1.1 PROJECT – H59-N300-CB

- A. HGTC GT Bldg. 500 Electrical and Fire Alarm Systems

- A. This Addendum consists of 7 page(s) including attachments (2 pages, 5 drawings).
- B. To Prime Bidders of Record:
1. This addendum forms a part of the Contract Documents and modifies the original Project Manual and Drawings. Acknowledge receipt of this addendum on the Bid Form. Failure to do so may cause a bid to be rejected as unresponsive as outlined in the Instructions to Bidders.

FIRST FLOOR POWER & SYSTEMS PLAN

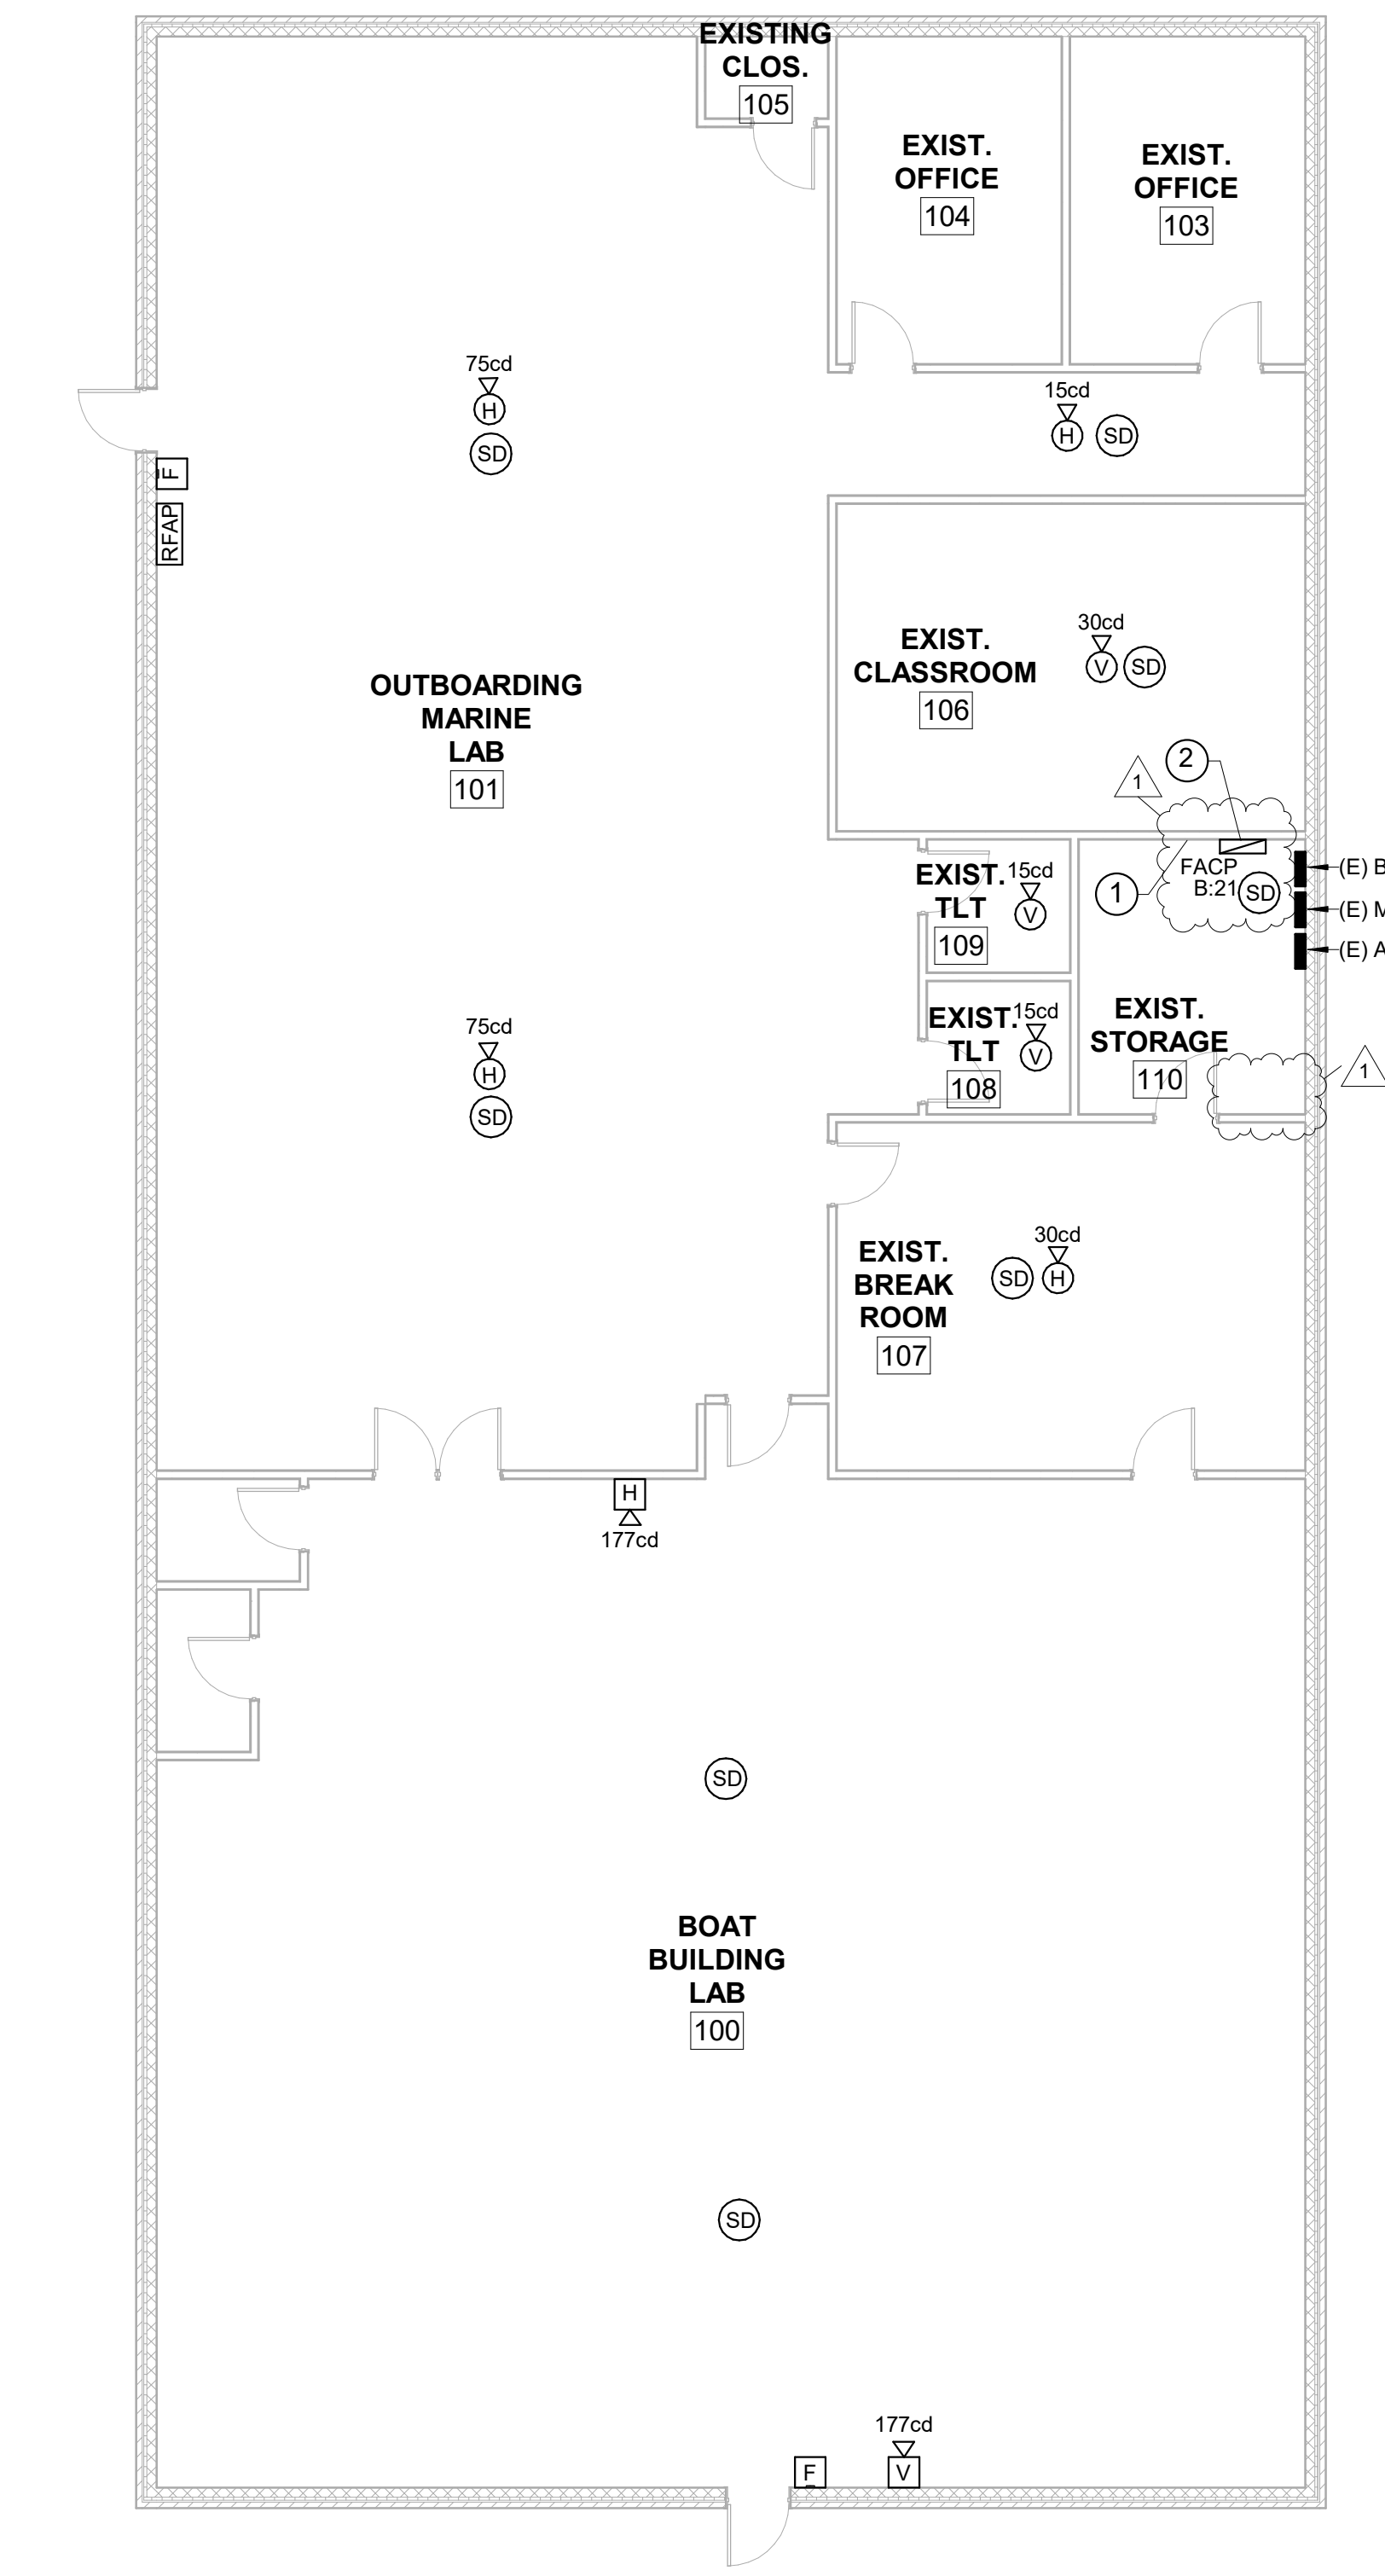
- A. The pre-bid conference held March 11th was not mandatory.
- B. The following changes/clarifications shall be made to the drawings. Revised drawings are attached.
1. E101
    - a. FACP location has been updated due to existing conflicts with the originally expected location.
- C. Questions:
1. Q: Is there an anticipated start and completion date for when this work should begin and end?

- 1 EXISTING WALL MOUNTED NETWORK EQUIPMENT.
- 2 COORDINATE FINAL LOCATION OF FACP ON-SITE WITH EXISTING CONDITIONS.
